|   | <b>Hope Bay Mining Project</b> |  |  |
|  | <b>Site Instruction</b>        |  |   |
|  |                                | <b>Contract Title:</b><br>Hope Bay 2011 Construction Scope – North Dam (Frozen Core Dam) |   |

| <b>Subject:</b> | North Dam Close-out Plan for April/May 2011 - FINAL |                   |                             |

|  |                         | Preferred Close-out Plan |               |           |

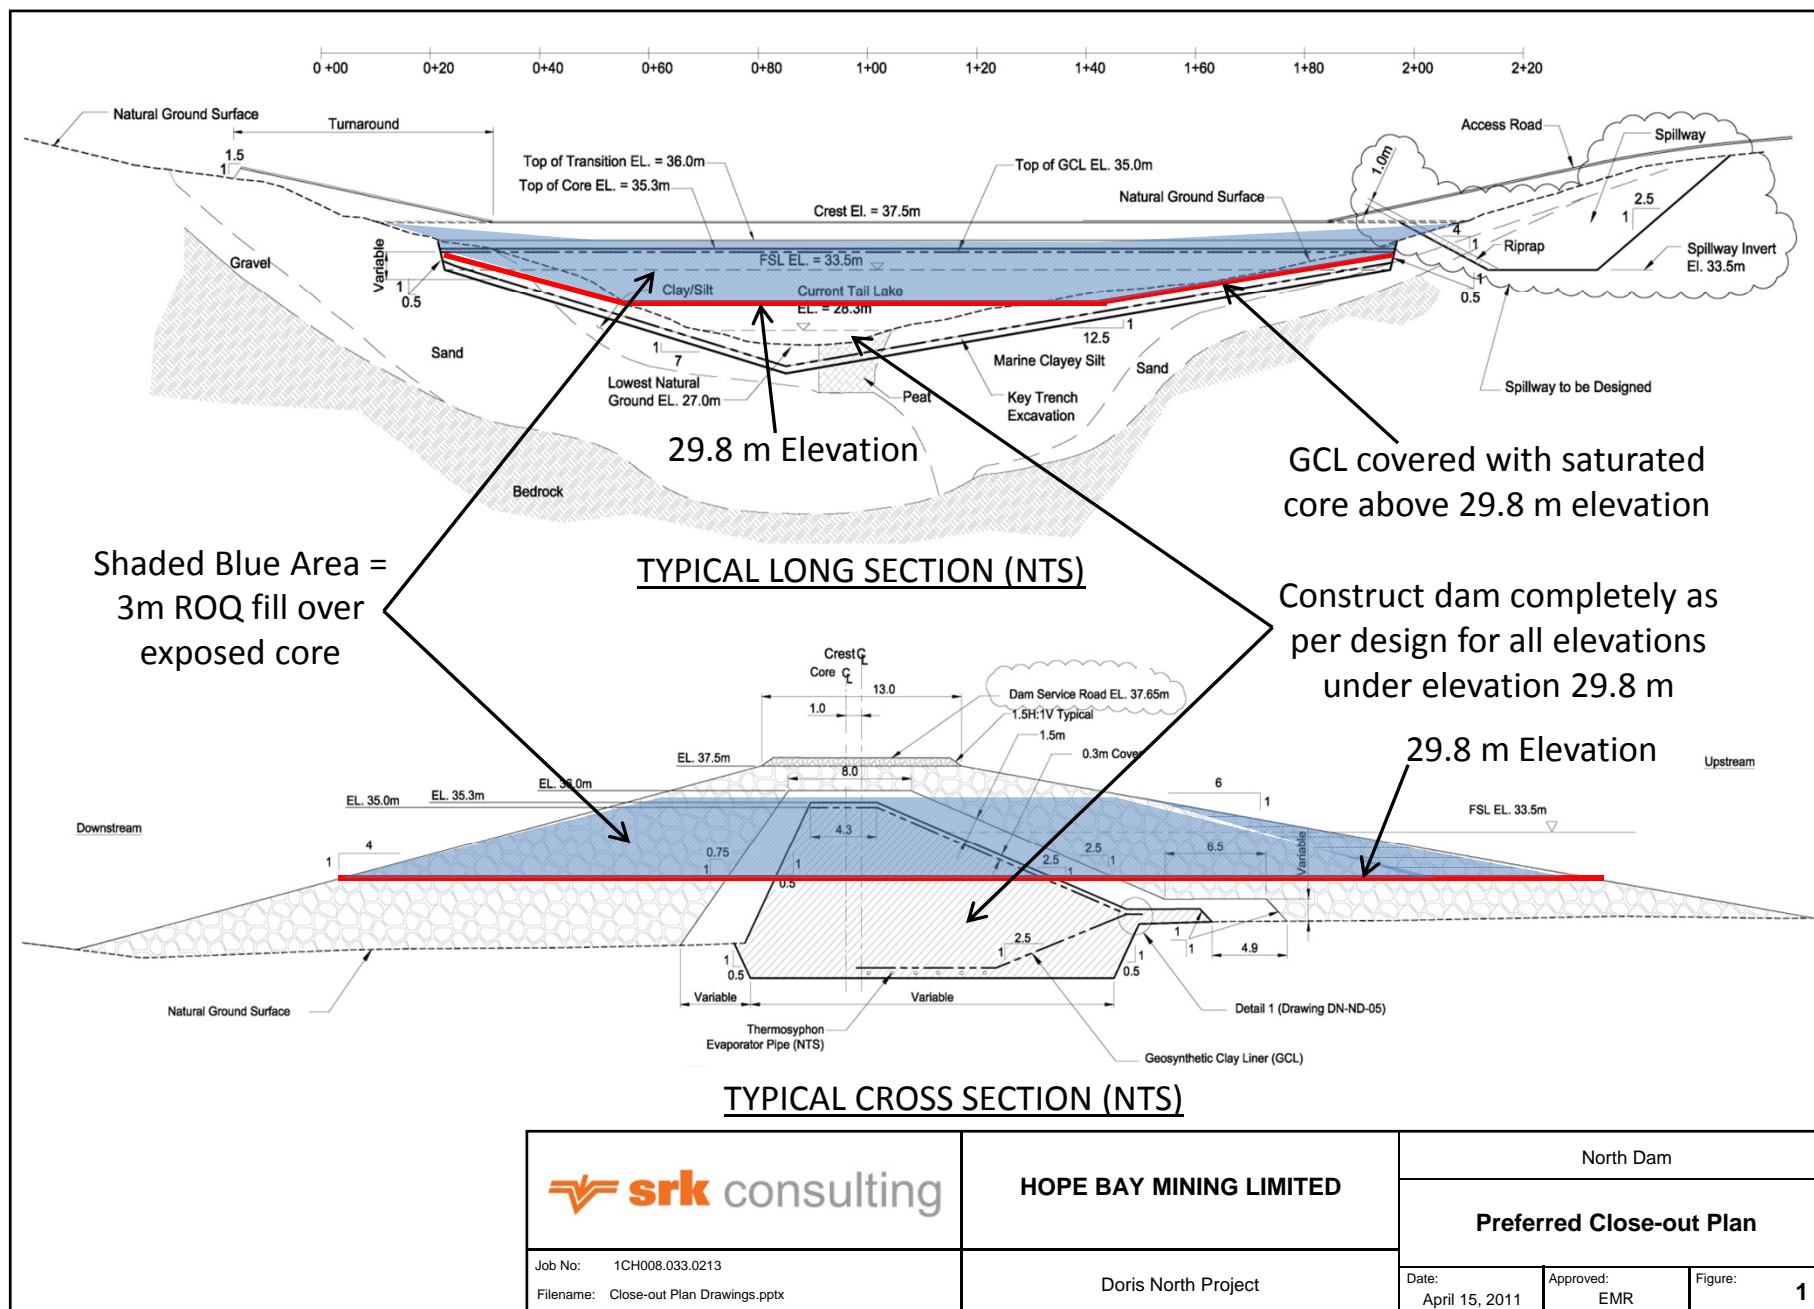
The preferred close-out plan (Figure 1) will continue the construction of the North Dam in accordance with the design, but with temporary modifications as follows:

- Install all evaporator pipes and radiators and commission the thermosyphons.
- Cover all evaporator pipes with saturated core material.
- Install all of the lower GCL (even those at elevation greater than 29.8 m), and cover with at least 500 mm (2 lifts) of saturated core material.
- Continue to construct the frozen core superstructure, as per design to elevation 29.8 m. This includes the installation of the upper CGL as appropriate, and covering it with saturated core material.

- It is expected that at least a portion of the uppermost saturated core material will degrade over the summer season, and will have to be removed when construction commences. Therefore, adequate cover is required over the elements embedded within the core (i.e. the evaporator pipes, GCL and ground temperature cables) such that when this sacrificial layer is removed there is no risk of damaging embedded elements.

- Sacrificial single bead ground temperature cables should be installed within the upper zone of the core material and in the layer containing embedded elements to allow monitoring of the sacrificial core material to assist with defining how much needs to be removed when dam construction commences.

- Complete the construction of both upstream and downstream abutments of the dam to elevation 29.8 m (this includes both ROQ and Transition material).
- Cover all of the exposed core material with 3 m of ROQ to act as temporary thermal protection until dam construction commences (a "marker" material layer could be placed if deemed necessary from a constructability perspective).

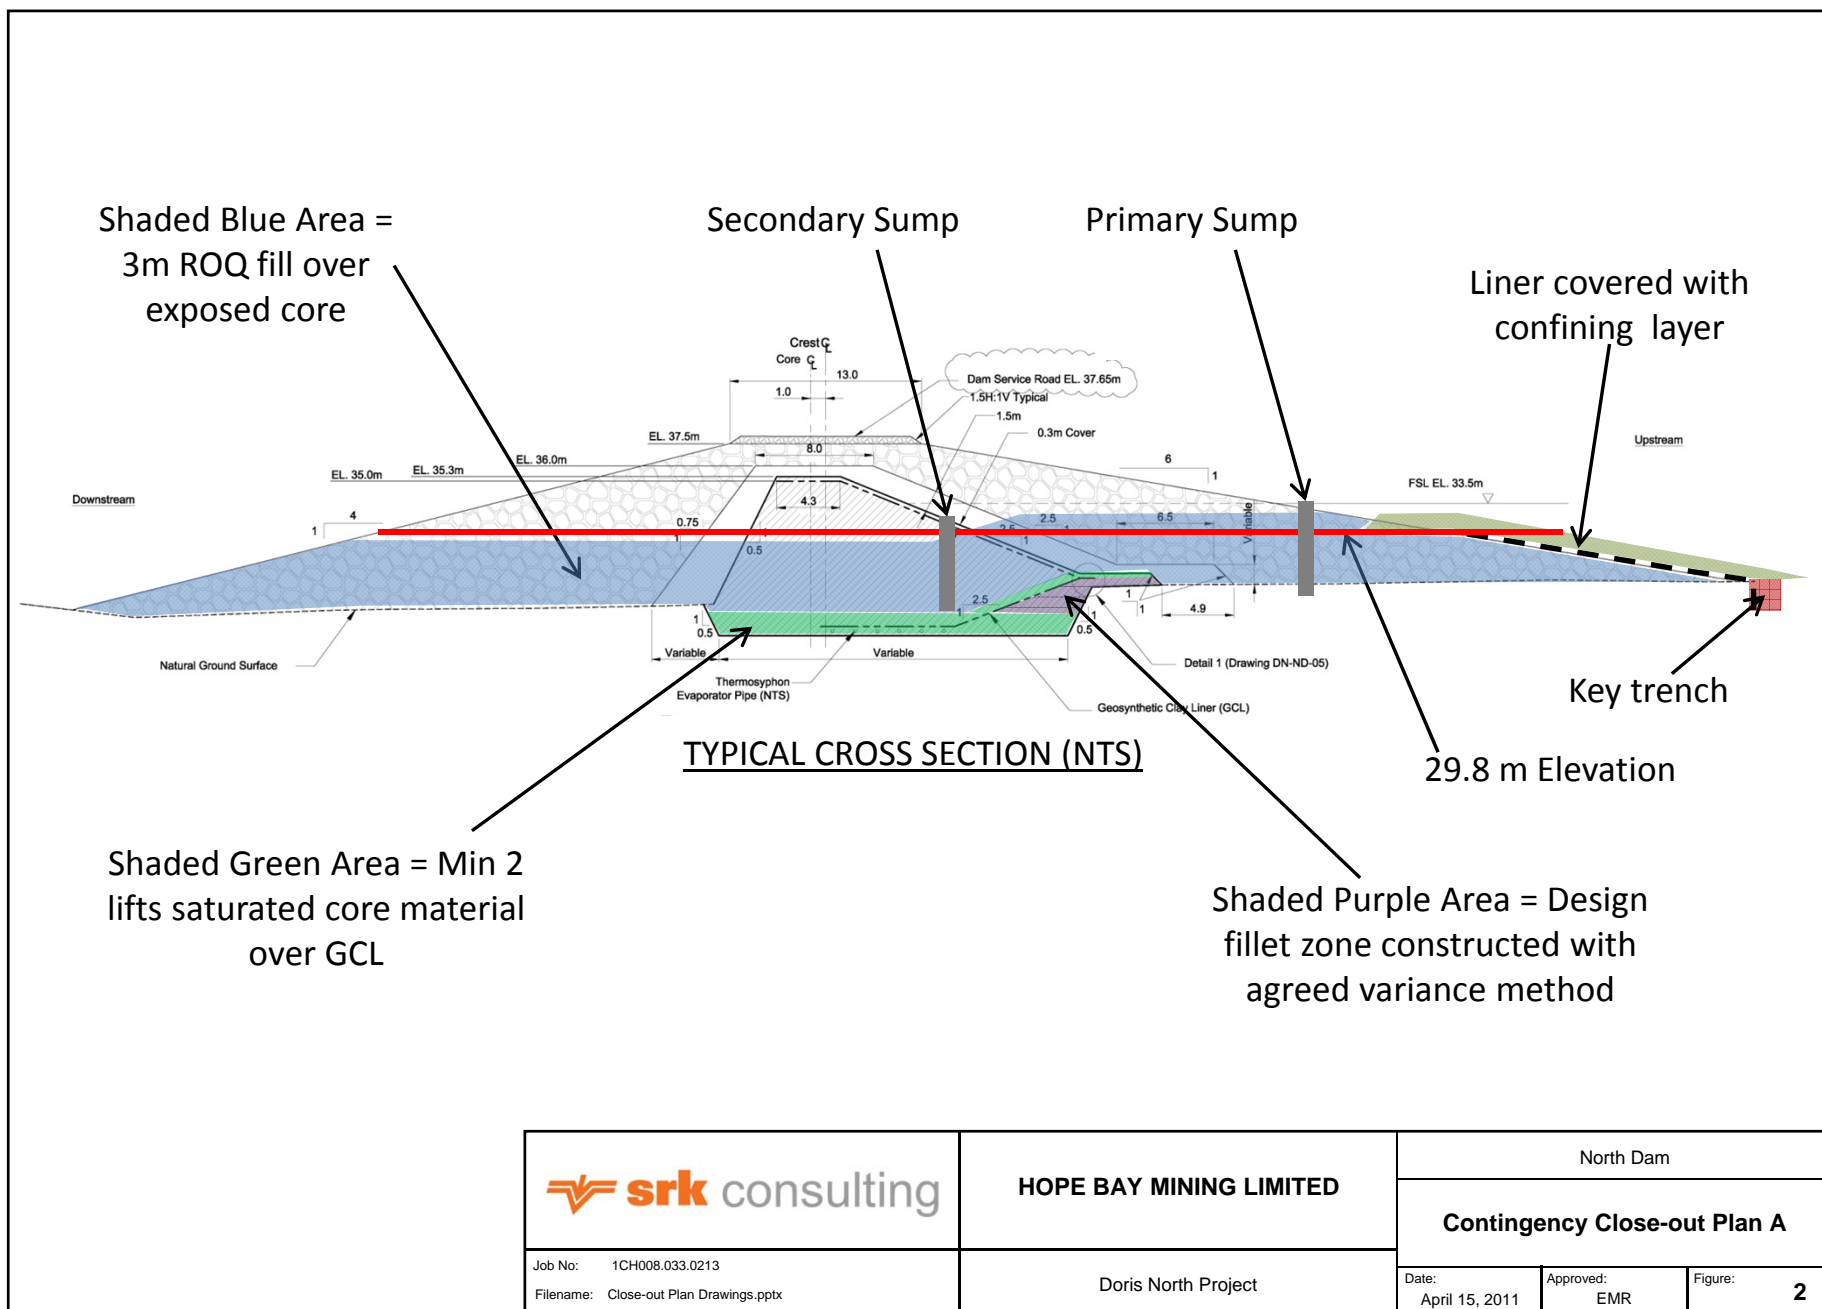
This contingency close-out plan, illustrated on Figure 2, consists of the following elements:

- Install a geosynthetic clay liner (GCL) on the upstream face of the dam up to elevation 29.8 m (note that this could be substituted with a HDPE liner if necessary; however, the HDPE would have to be sandwiched between two 12-oz geotextile layers, and/or appropriate bedding layers). The neat line quantity for this liner (not accounting for overlap and wastage) is about 1,100 m<sup>2</sup>.

- The liner (GCL or HDPE) should be keyed as far as practical, into original ground at the toe of the dam to penetrate below the active zone (about 0.5 to 1 m deep) and be embedded into frozen ground. It is recognized that the ground will be frozen, therefore excavation of this trench will not be easy; however, to cut off the seepage path leading to the exposed core material an effective key trench is required.

- At the crest, the liner (GCL or HDPE) does not need a tuck trench but it needs to extend at least 1.5 m beyond the crest and should be covered with at least 0.5 m of select ROQ to act as ballast.

- On the slope, the HDPE liner needs to be covered with at least 1 m of select ROQ to ensure a confining load (should HDPE be used, no confining load is required; however, covering the liner with a nominal lift (300 mm) of crush material would be advantageous to counter the heat sink created by the black surface of the HDPE).

- The key trench should be backfilled with core material to ensure protection of the liner. If the key trench bottom surface is highly irregular, bentonite powder should be used to ensure a good seal between the liner and the excavation. The backfilled key trench should be covered with at least 1 m of select ROQ extending 1 m upstream of the key trench limit to provide thermal insulation.

- A primary sump, excavated at least 1 m below the lowest original ground level needs to be installed through the existing ROQ material downstream of the liner (approximately at station 0+85), but upstream of the core material (at least 10 m upstream). The sump should consist of a vertical corrugated steel pipe culvert (at least 24-inches in diameter), perforated at the base. A trash pump with an automated level switch should be installed in the pipe culvert to transfer any seepage bypassing the liner back to Tail Lake. *SRK will provide an estimate of the seepage rate to allow sizing of the pump.*

- A secondary sump, complete with trash pump and level sensor, similar to the first is required in the low spot of the key trench on top of the core material (approximately at station 0+85). *SRK will provide an estimate of the seepage rate to allow sizing of the pump.*

|  |                         | Contingency Close-out Plan B |               |           |

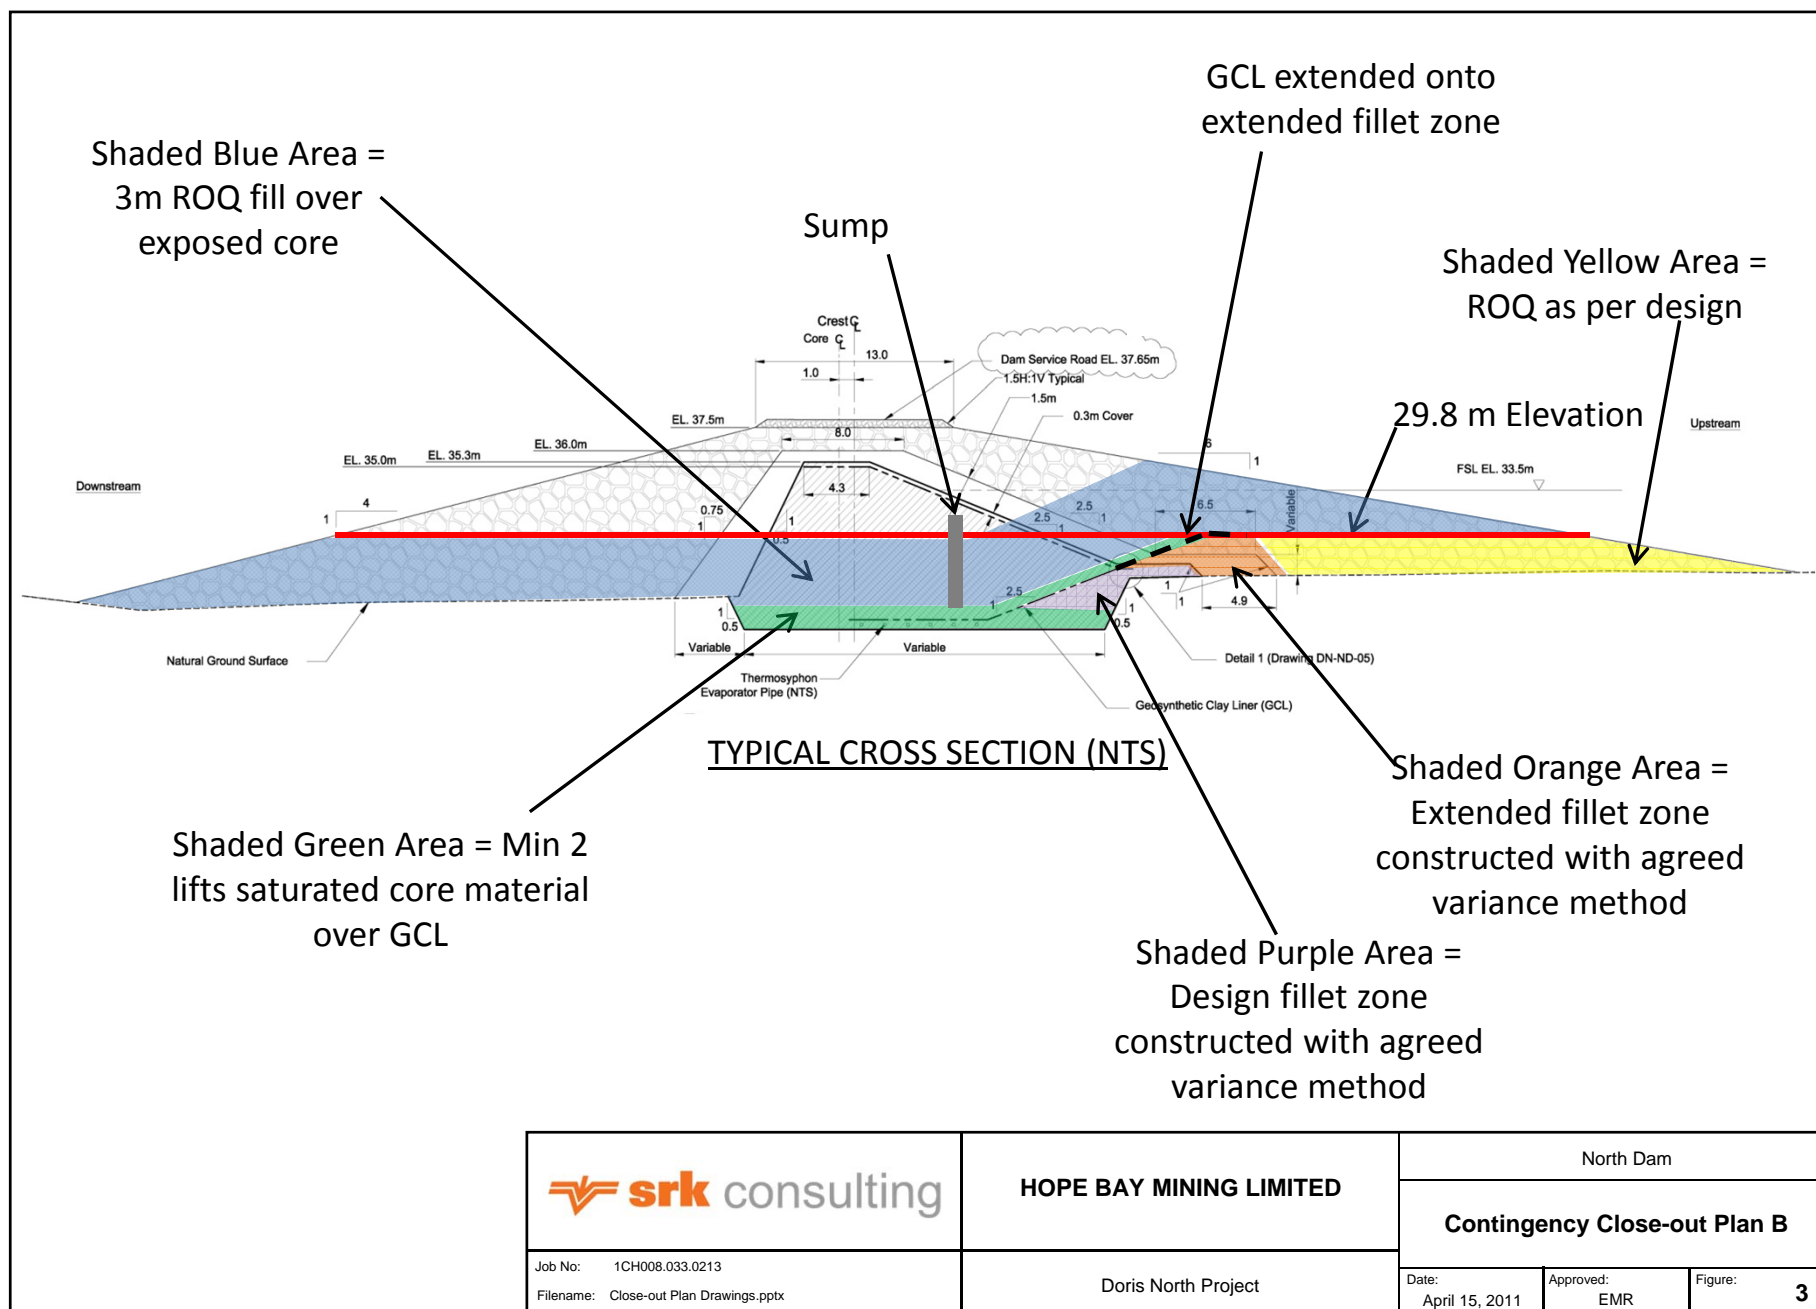
The following elements describe this contingency close-out plan, as illustrated on Figure 3:

- Rather than terminating the fillet zone at the design elevation for the lower GCL, extend the fillet zone to elevation of 29.8 m where appropriate. This additional fillet will be constructed in accordance with the approved variance for fillet construction, and will continue rising at a slope of 2.5:1.

- The final crest width of the extended fillet zone, at elevation 29.8 m, must be at least 3.5 m wide. The upstream slope of the extended fillet can be 1:1 down to original ground.

- Prior to extending the fillet zone as described above, the tundra vegetation must be stripped from the footprint where this extended fillet material will be placed.

- Cover the extended fillet with GCL by extending the lower GCL coming from the key trench. Terminate the GCL 1 m beyond the crest of the 29.8 m elevation on the horizontal surface.

- Cover the entire GCL surface with at least 500 mm (2 lifts) of saturated core material.
- It is anticipated that at least a portion of the uppermost saturated core material will degrade over the summer season, and will have to be removed when construction recommences. Therefore, adequate cover is required over the elements embedded within the core (i.e. the evaporator pipes, GCL and ground temperature cables) such that when this sacrificial layer is removed there is less risk of damaging embedded elements. As stated above, the minimum saturated core over these elements prior to close-out is 0.5 m (2 lifts)

- A sump needs to be installed in the low spot of the key trench on top of the core material (approximately at station 0+85). The sump should consist of a vertical corrugated steel pipe culvert (at least 24-inches in diameter), perforated at the base. A trash pump with an automated level switch should be installed in the pipe culvert to transfer surface inflows downstream of the extended fillet zone back to Tail Lake. *SRK will provide an estimate of the inflow rate to allow sizing of the pump.*

- Please follow Contingency Close-out Plan B as related to construction activities at the North Dam from this date forward.
- The 3 m of material required to provide thermal protection over the core material should consist of 0.5 m of what has been termed 5/8" clear rejects and 2.5 m of ROQ from Quarry #2.
- When these materials are excavated next fall they must be well mixed when stockpiled and later placed as they will be used to construct the ultimate shell zone of the dam.

SRK recommends that contingency close-out Plan B be implemented. Specific details on placement of the single bead ground temperature cables, placement of the sump and extent of the ROQ cover,
